**FULL DESIGN REVIEW
RECOMMENDATION MEETING
#3029350**

**2328 - 2334 FRANKLIN AVE E
June 5, 2020**

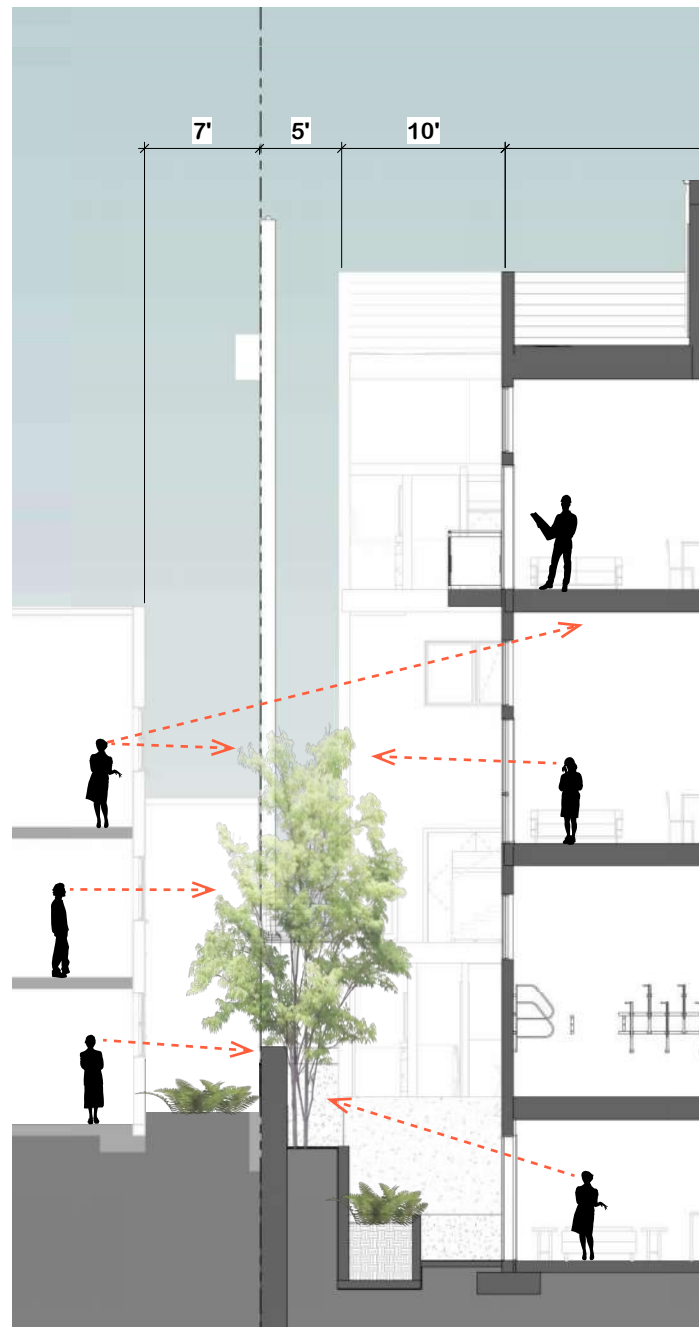
a. Due to existing topography, the subject lots are situated significantly above sidewalk level, increasing the perceived height of any proposed structure. The Board asked that the applicant be mindful of this additional perceived height and use modulation, materials, and proportions that do not further exaggerate the perceived height of the structure. (CS1-C)

b. The Board was concerned about how topography will impact the quality of proposed basement-level units. Prepare additional section drawings and renderings of the basement-level courtyard conditions for the recommendation phase of review. Develop these spaces to provide abundant natural light, greenery, and a sense of connection to the rest of the development. (CS1-B-2, CS1-C-1)

DESIGN RESPONSE: We have continued to develop the project in a manner consistent with the precedents outlined in the EDG packet, focusing on a simple, “whole” building design with a restrained, high quality material palette and simple massing consistent with the surrounding fabric. We have emphasized the use of secondary massing elements that break down the perceived scale of the building, such as the entry porch, projecting balconies, grouping of the windows, and replacement of the parapet with a glass railing system.

DESIGN RESPONSE: Section drawings have been provided to demonstrate access to light for the basement units. Along the front façade, a gentle terracing that extends across the front of the building to bring light into the basement. The north and south facing basement units have walk-out terraces and large double glass doors. For the east facing units we have increased the setbacks from five feet (5') to seven feet (7') to allow for a more generous light well to serve those units.

BUILDING TOP ANALYSIS

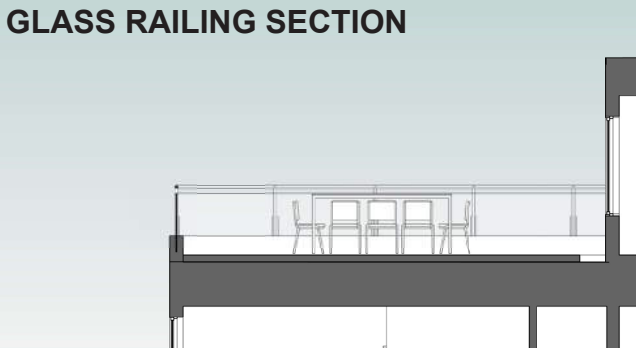
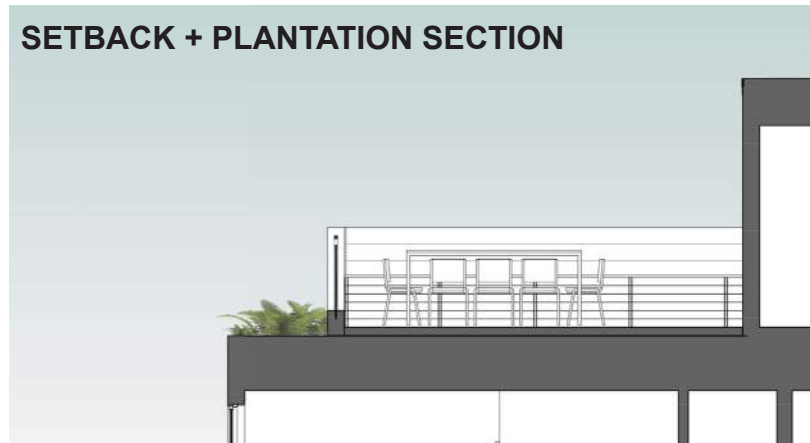
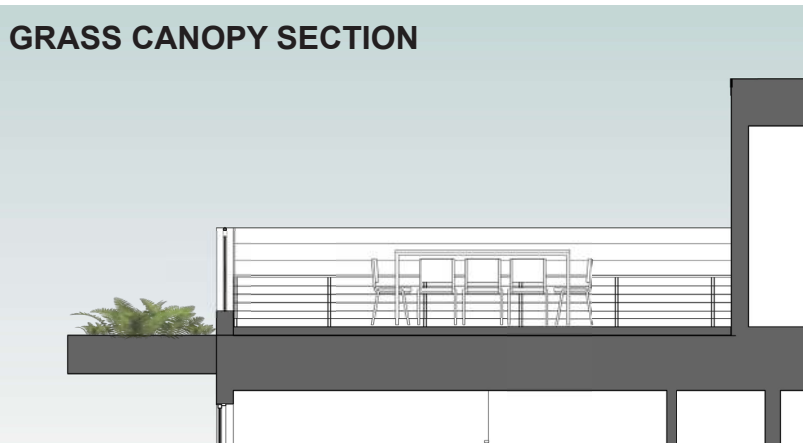
b. The Board gave guidance to provide a strong roof termination, particularly on the street-facing façade. The roof deck railing needs to be thoughtfully integrated with the primary façade or pulled back from the street edge to hide it from view. (DC2-B-1, DC3-A-1).

DESIGN RESPONSE: Along the street facing façade the top of the building terminates in a glass railing in lieu of a more conventional parapet. The glass railing help reduce the apparent scale of the building and draws human activity right up to the edge of the building face. Pulling the railing back from the

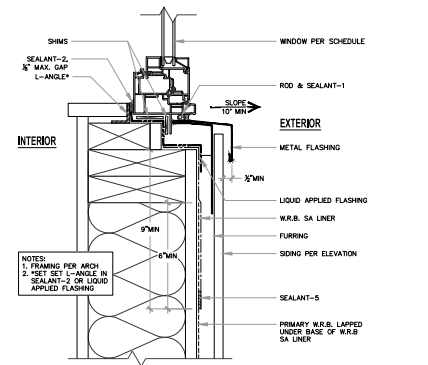
a. Both the existing neighborhood character and the type of development proposed (condominium building) require high quality, long-lasting materials. The use of brick is strongly encouraged. (CS3-A, DC4-A).

DESIGN RESPONSE: The proposed design proposes the use of OKO-skin siding at the primary public facades. OKO is a heavy duty, integrally colored fiber cement siding plank that has a material quality and visual heft that is reminiscent of masonry, without the attendant weight and waterproofing issues associated with masonry veneer. We have used OKO skin at previous project such as the Hamilton Apartments to provide a high quality, durable siding material that conveys heft, permanence, and material quality.

RECESSED WINDOW DETAILS:

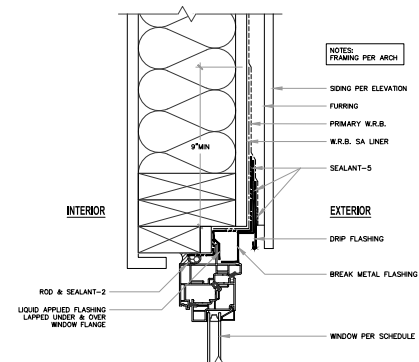
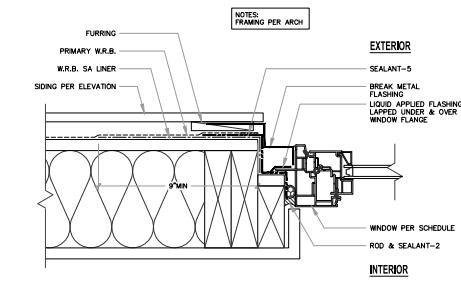
b. Provide detailed window diagrams in the Recommendation packet, including depth of glazing and mullion locations. (DC2-B, DC2-C)

DESIGN RESPONSE: Please see recessed window detail below.

PRIVACY SECTIONS

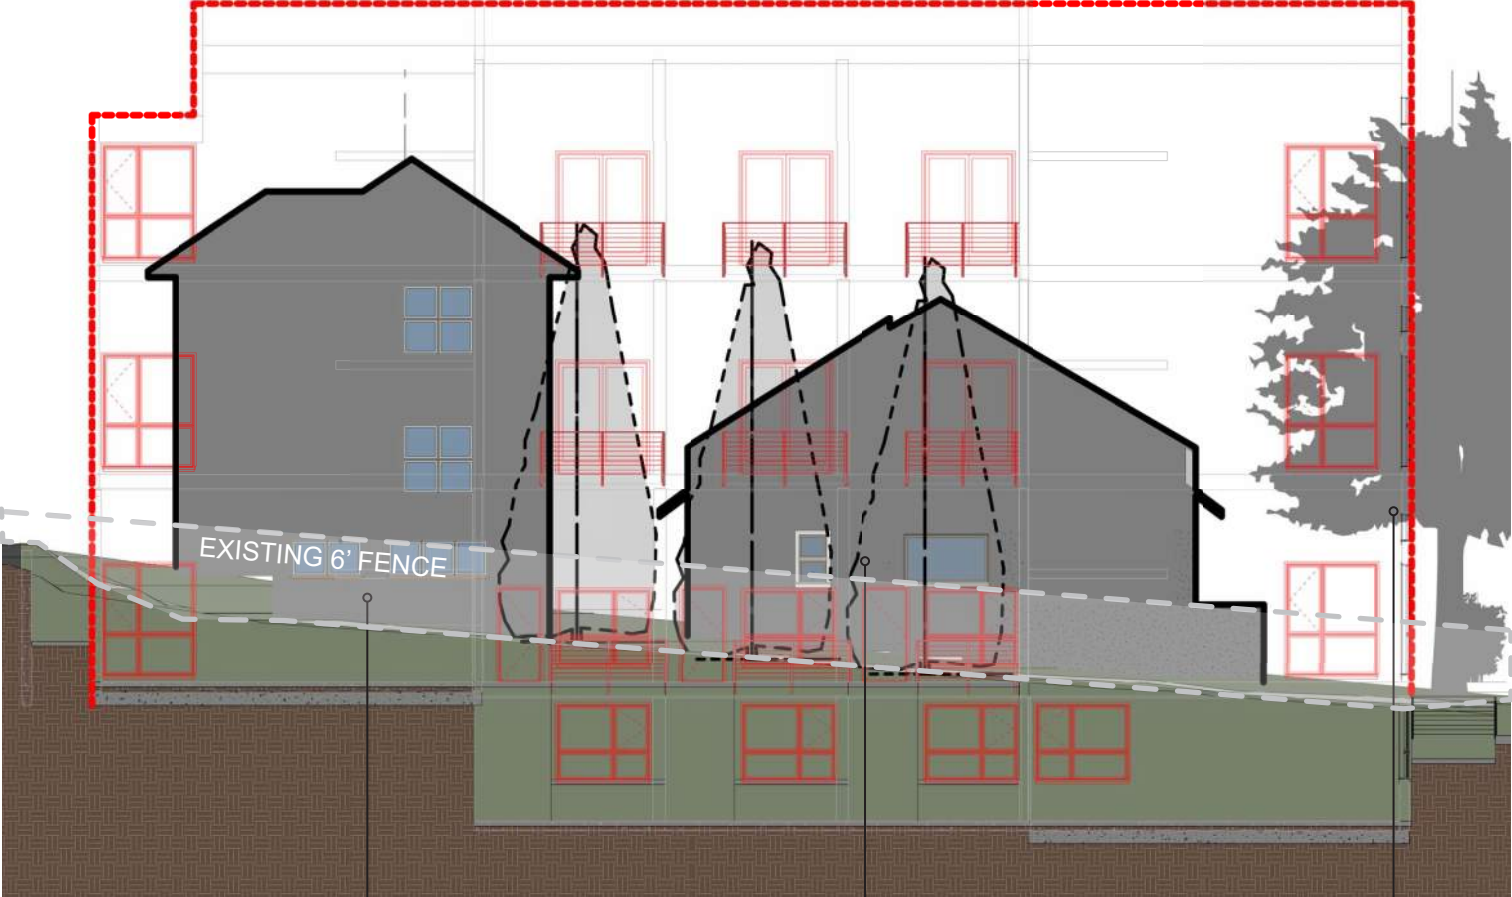
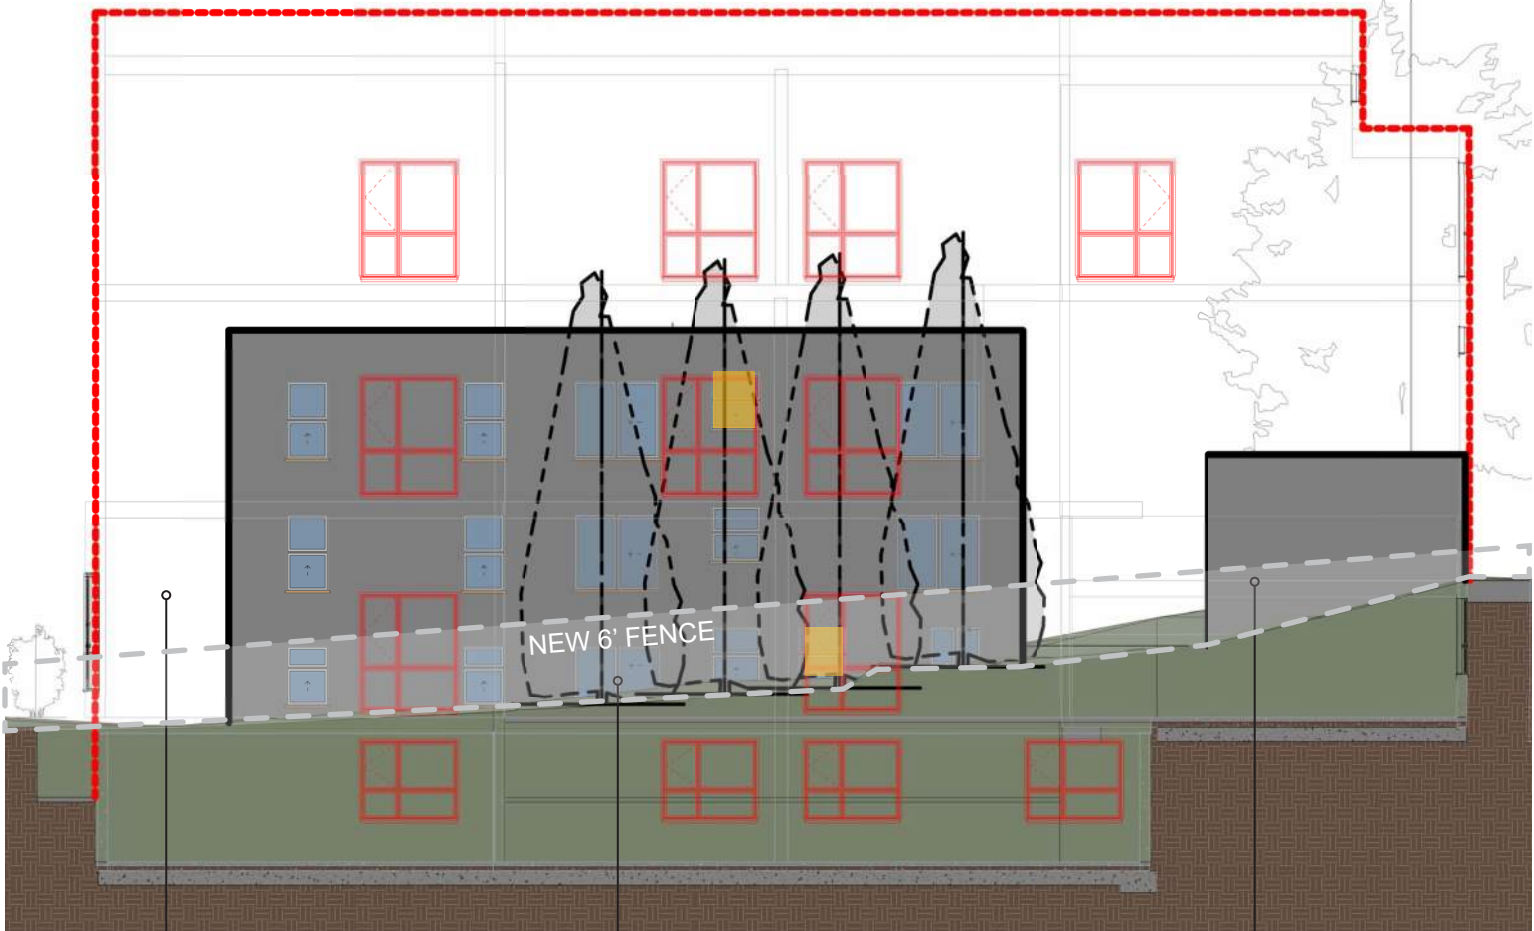
a. At the Recommendation meeting, the Board would like to see additional section drawings at side property lines & court-yards. Show proposed terraces and land-scaping and how they relate to basement-level units. (DC3-A, DC3-B)

DESIGN RESPONSE: See Basement Unit Privacy / Landscape Detail sections on page 39 and Privacy Sections on page 50.
